MAHONING ROAD NE
 STA-0153-01.70

INTERSECTION DETAILS
GRACE AVENUE NE / INIANA AVENUE NE

REVISIONS	DATE	BY
CONSTRUCTION BIDDING SET	4/21/14	GEA
ADDENDUM NO. 1	5/7/14	GEA
STM SWR REVISIONS	10/1/14	GEA

STREETSCAPE PLAN
STA. 66+50 TO STA. 78+00

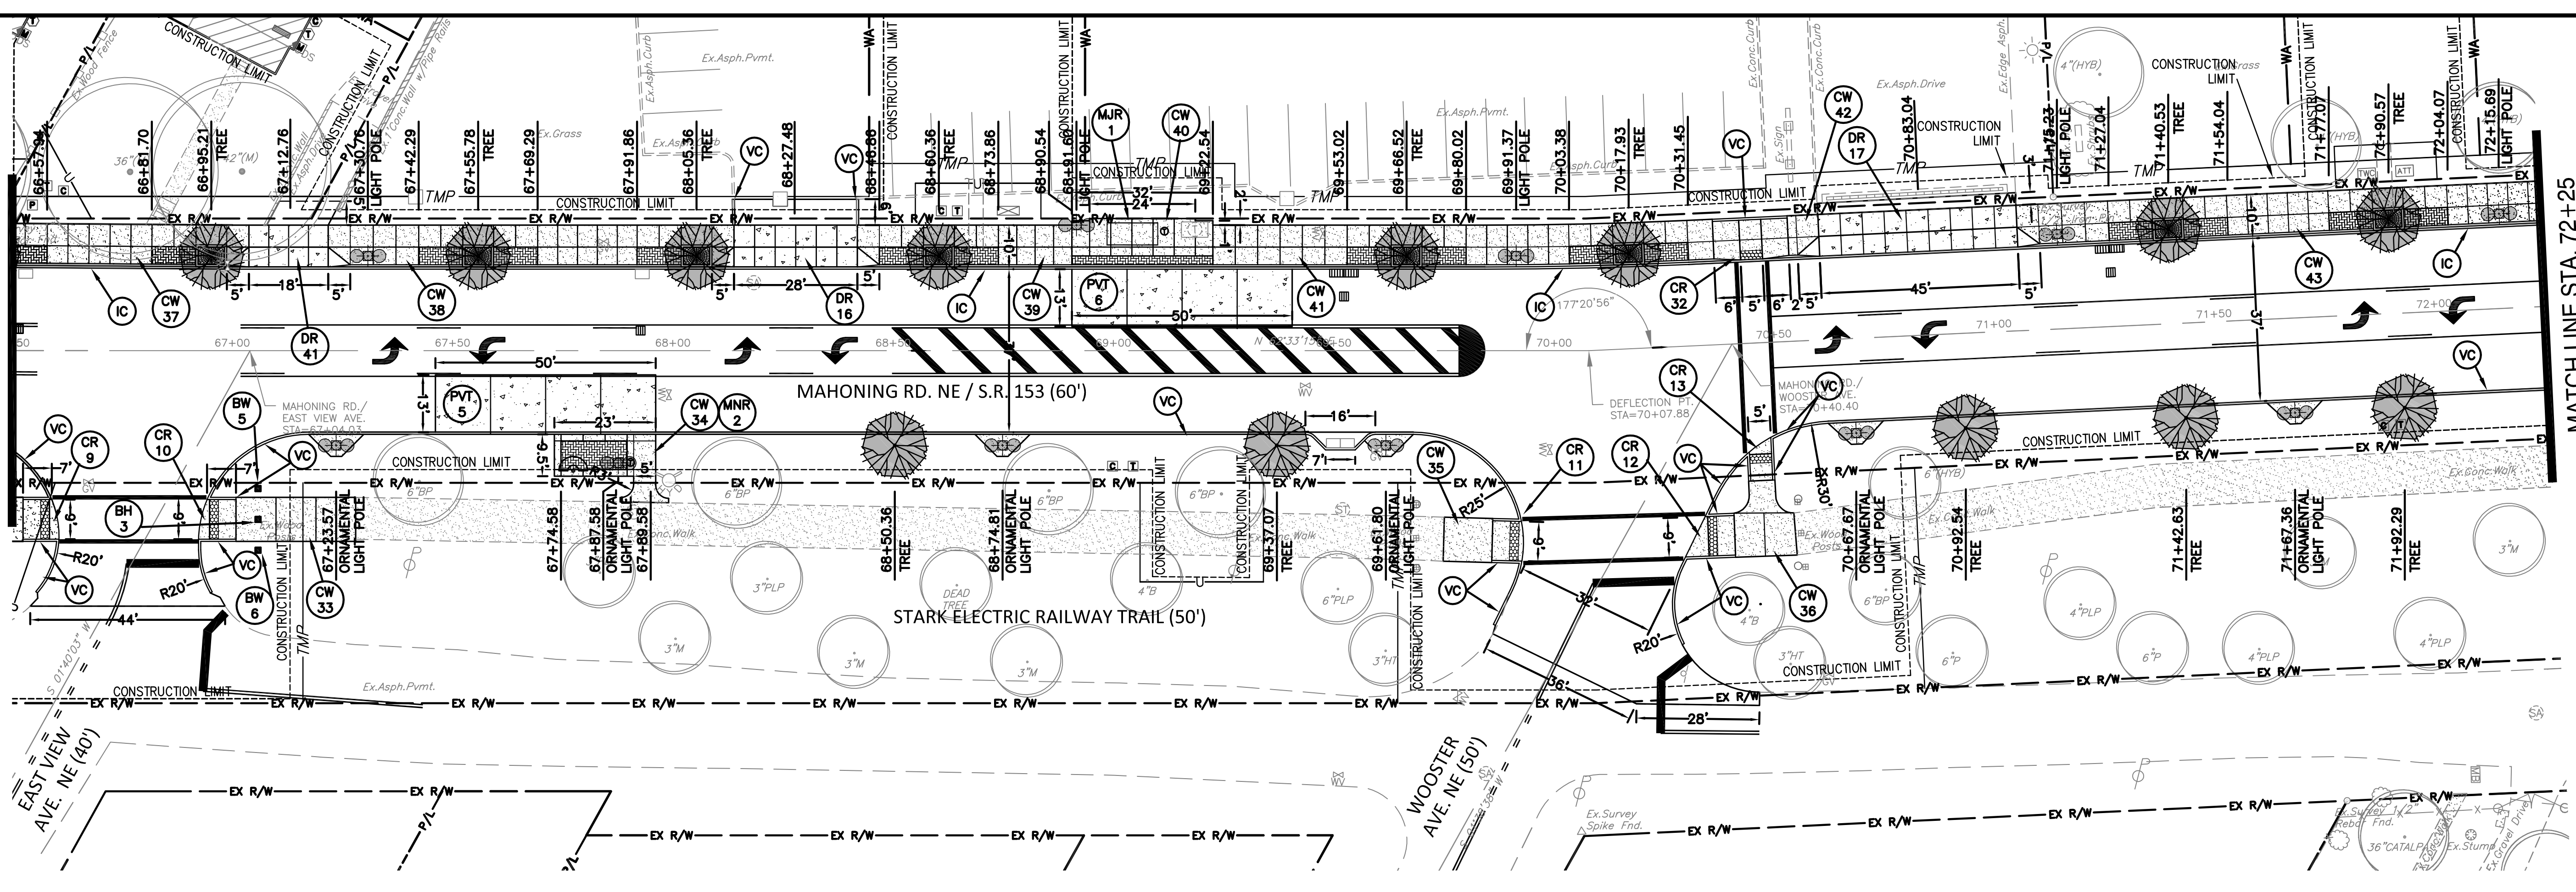
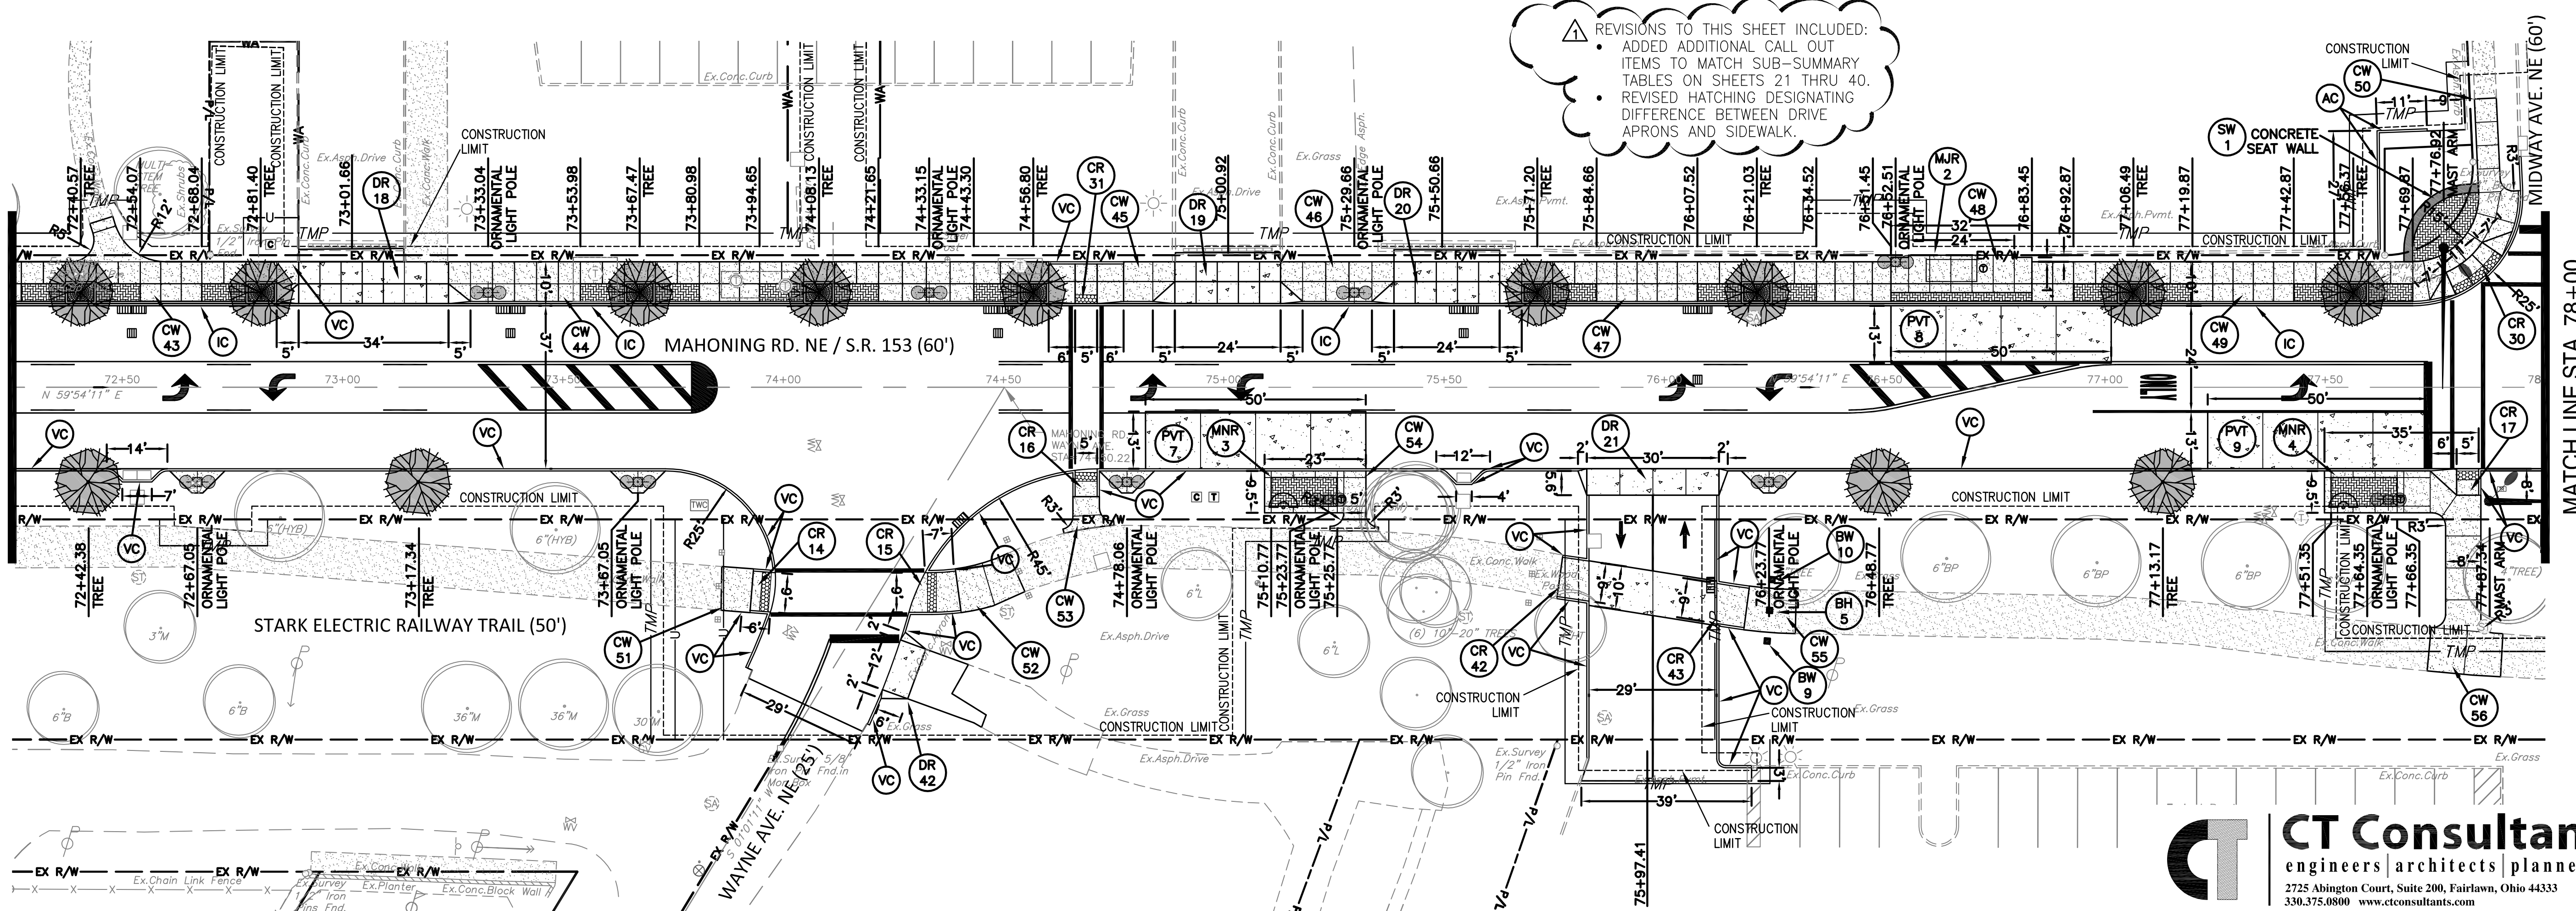
REVISIONS TO THIS SHEET INCLUDED:

- ADDED ADDITIONAL CALL OUT ITEMS TO MATCH SUB-SUMMARY TABLES ON SHEETS 21 THRU 40.
- REVISED HATCHING DESIGNATING DIFFERENCE BETWEEN DRIVE APRONS AND SIDEWALK.

STREETSCAPE PLAN
STA. 78+00 TO STA. 89+50

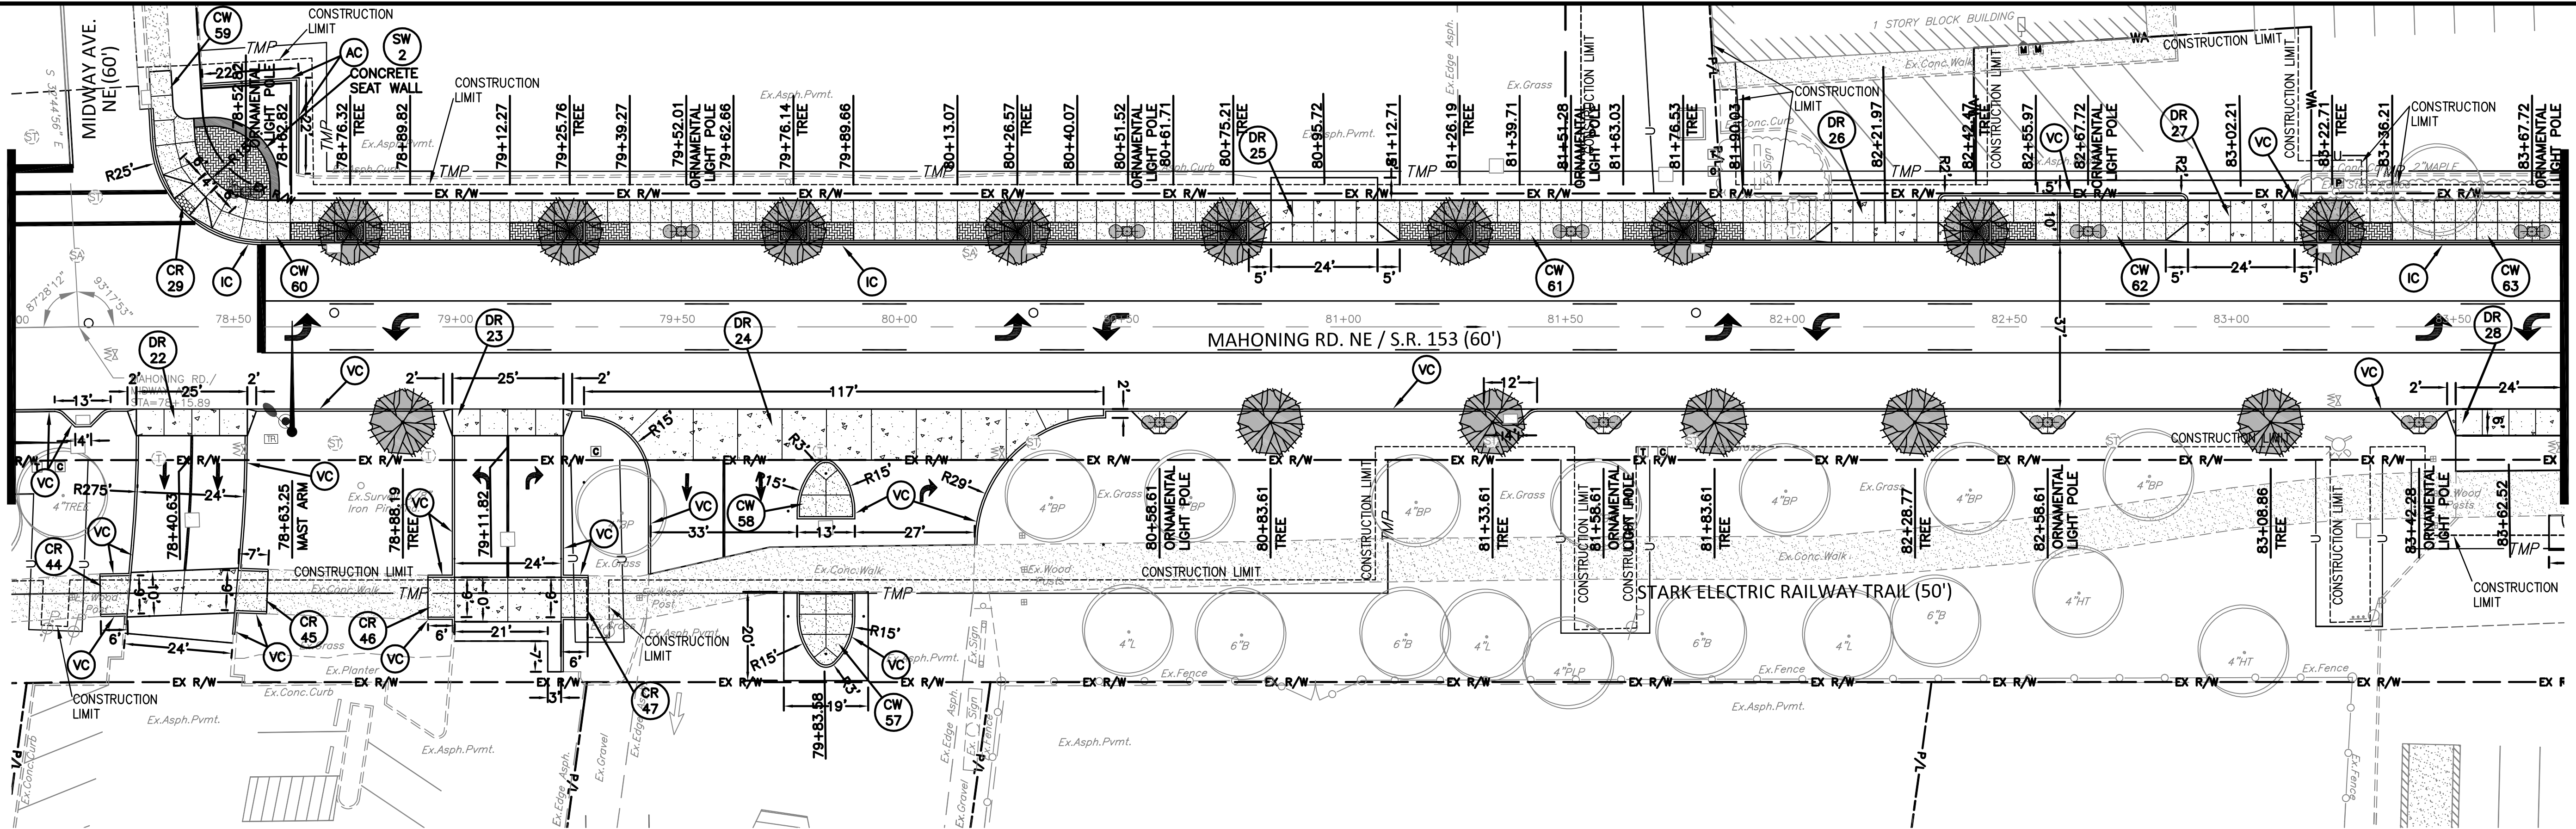
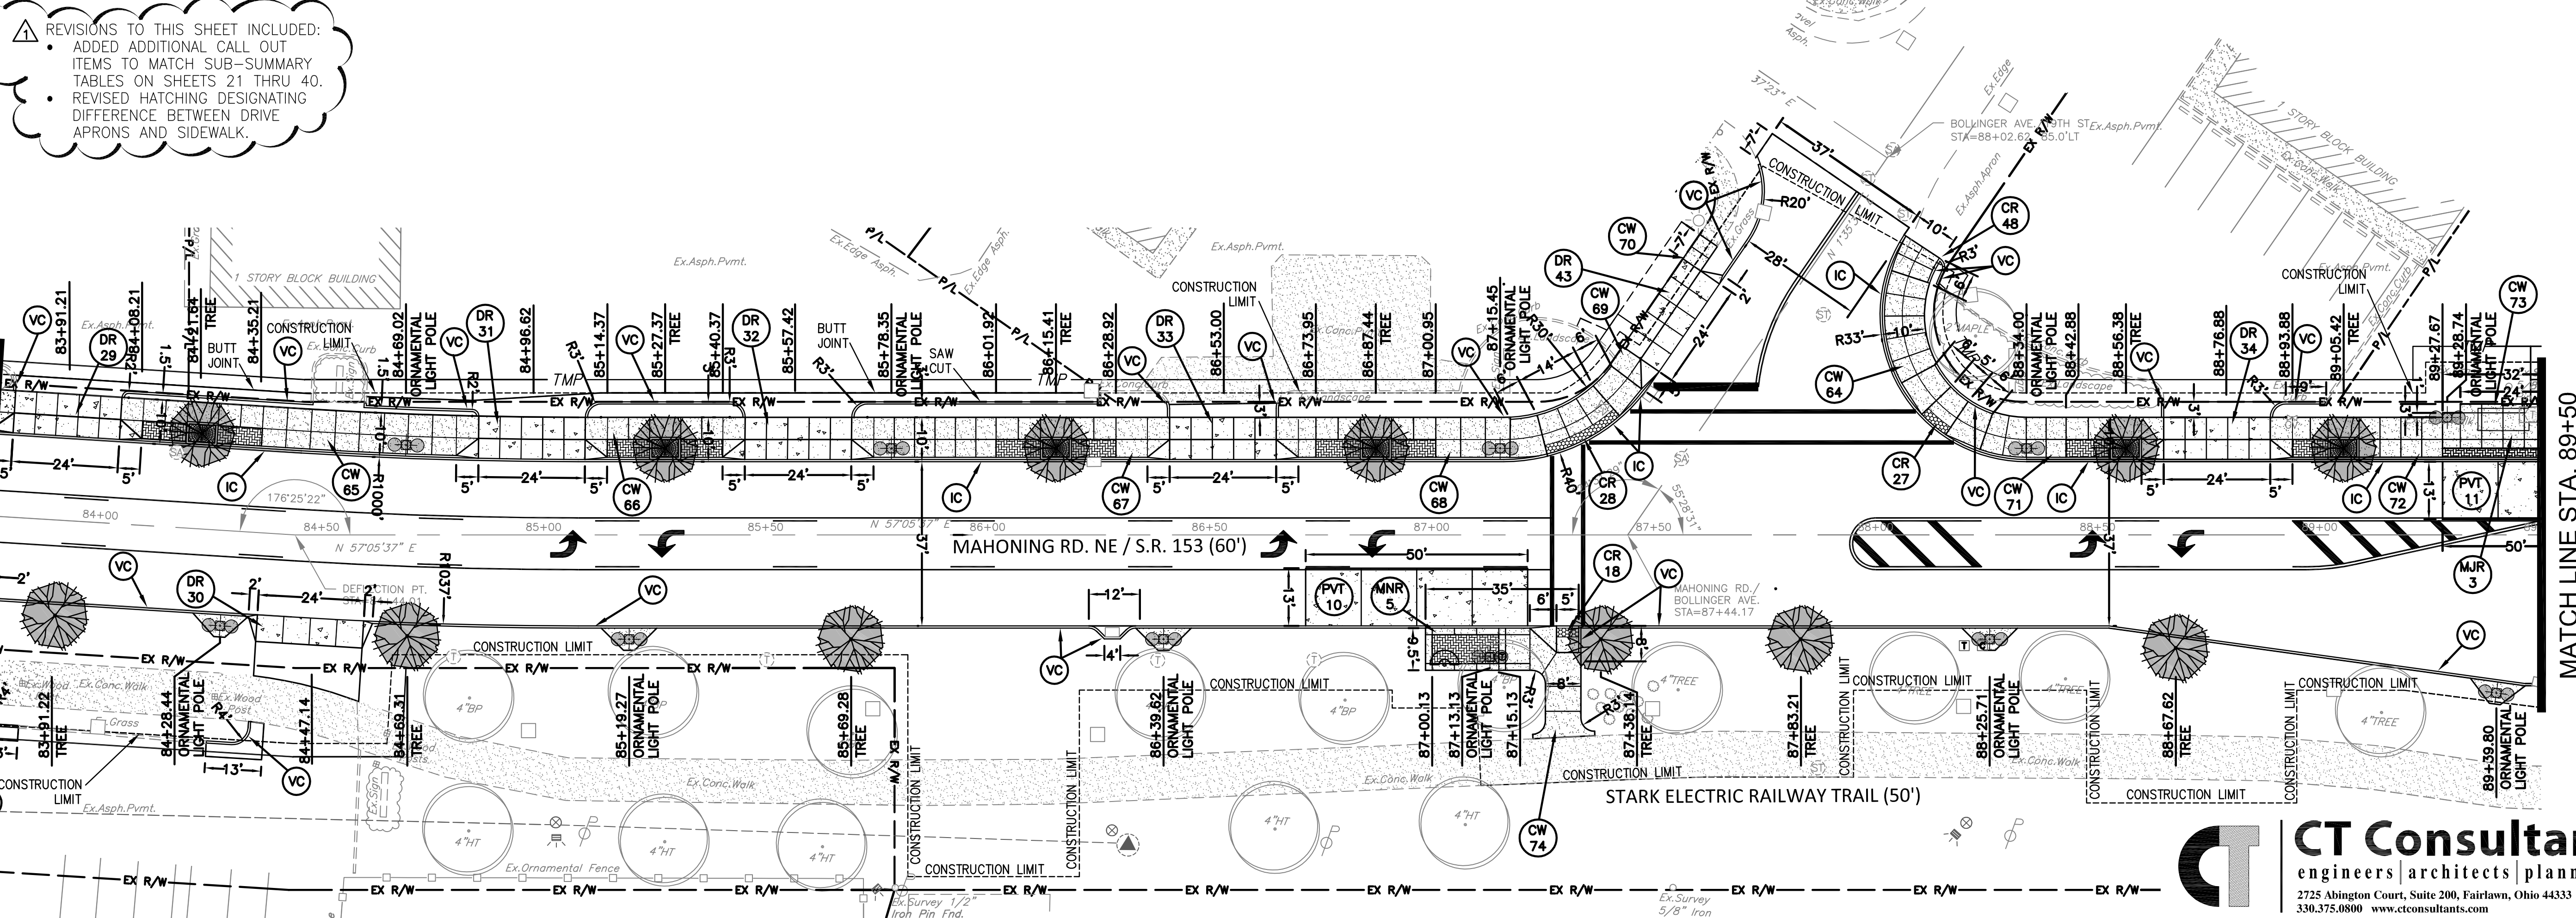
REVISIONS TO THIS SHEET INCLUDED:

- ADDED ADDITIONAL CALL OUT ITEMS TO MATCH SUB-SUMMARY TABLES ON SHEETS 21 THRU 40.
- REVISED HATCHING DESIGNATING DIFFERENCE BETWEEN DRIVE APRONS AND SIDEWALK.
